# Technical Service Bulletin

**20 EVAP charcoal filter line (N80) - ticking/thumping noise in passenger compartment (rear) - V6 3.0 TFSI**  
20 23 60 2067759/2 May 5, 2023. Supersedes Technical Service Bulletin Group 20 number 23-57 dated April 25, 2023, for reasons listed below.

Model(s)	Year	VIN Range	Vehicle-Specific Equipment
Q8	2019 – 2023	All	Not Applicable

*Figure 1: Sleeve 4KD 201 255.*

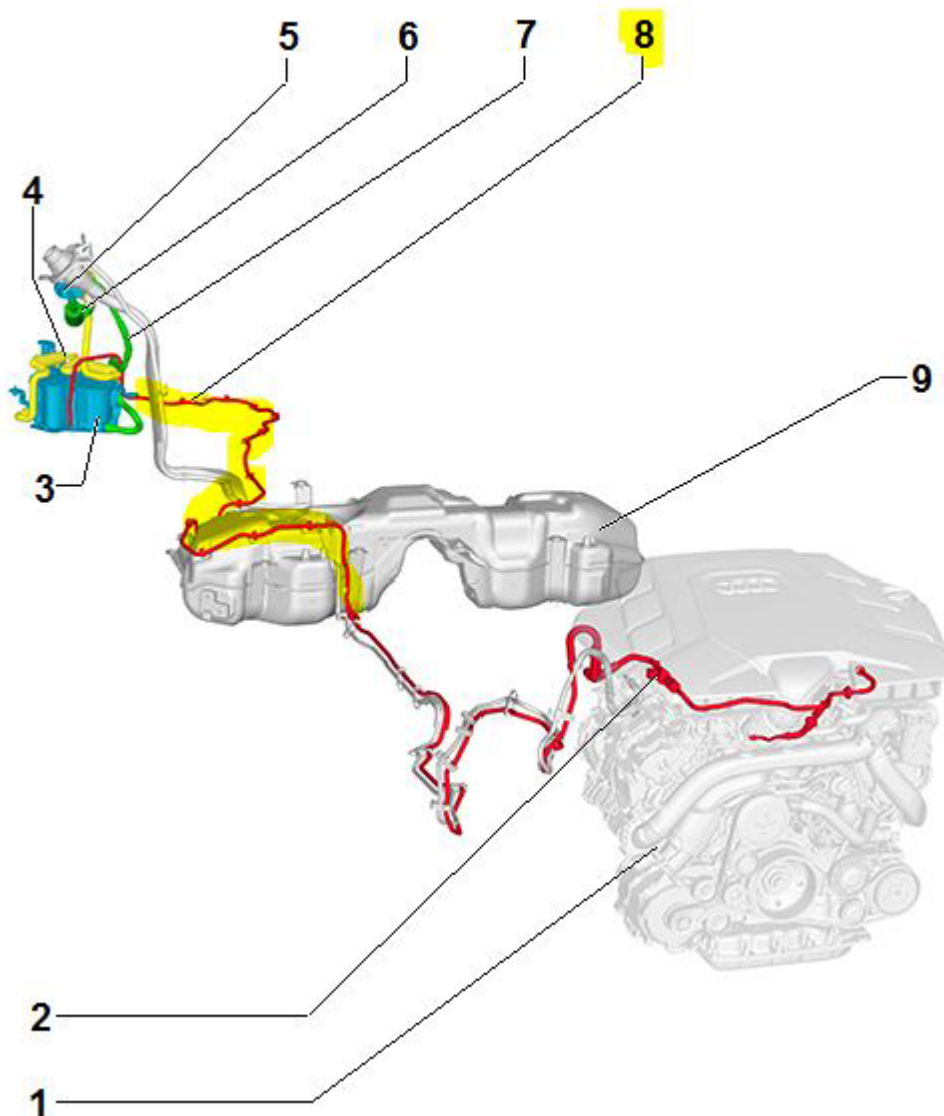
1. Fit sleeves (figures 1, 2) with part number 4KD 201 255 on the activated charcoal filter line (figure 3, item 8).

**Figure 4:** Vehicles without air suspension and without rear wheel steering (PR no. 1BL) - 10 sleeves.

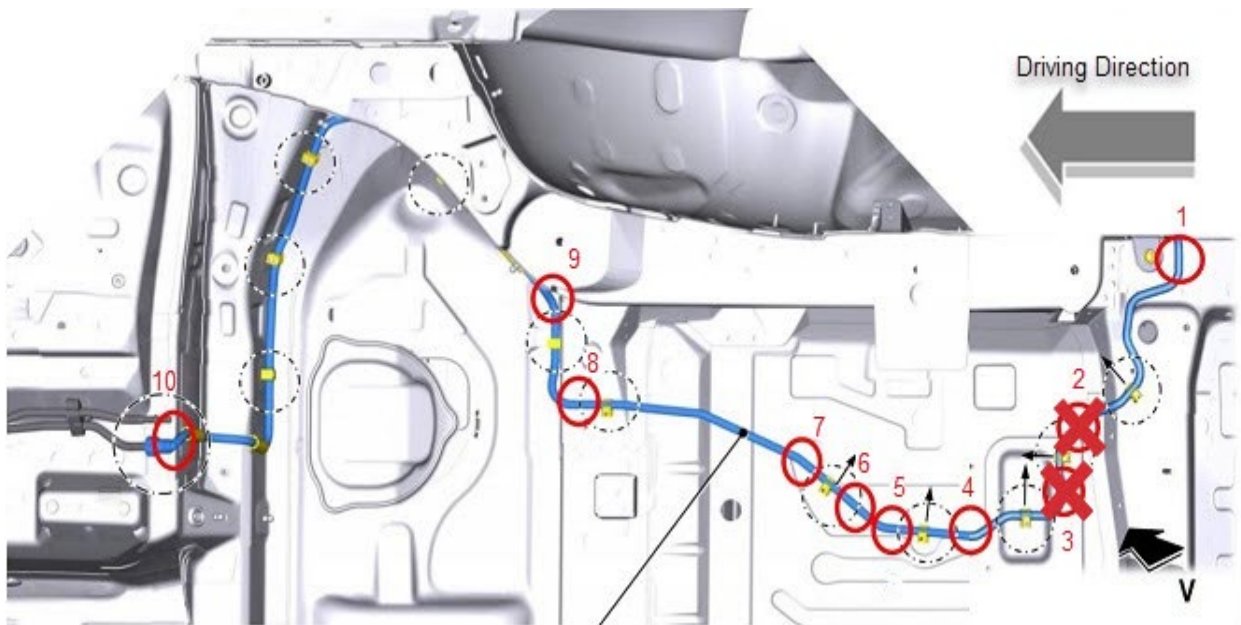
2. The number of sleeves depends on the equipment version of the vehicle (PR number) when it was manufactured. Use the following overviews (figures 4, 5, and 6) to determine how many sleeves are required and their positions.
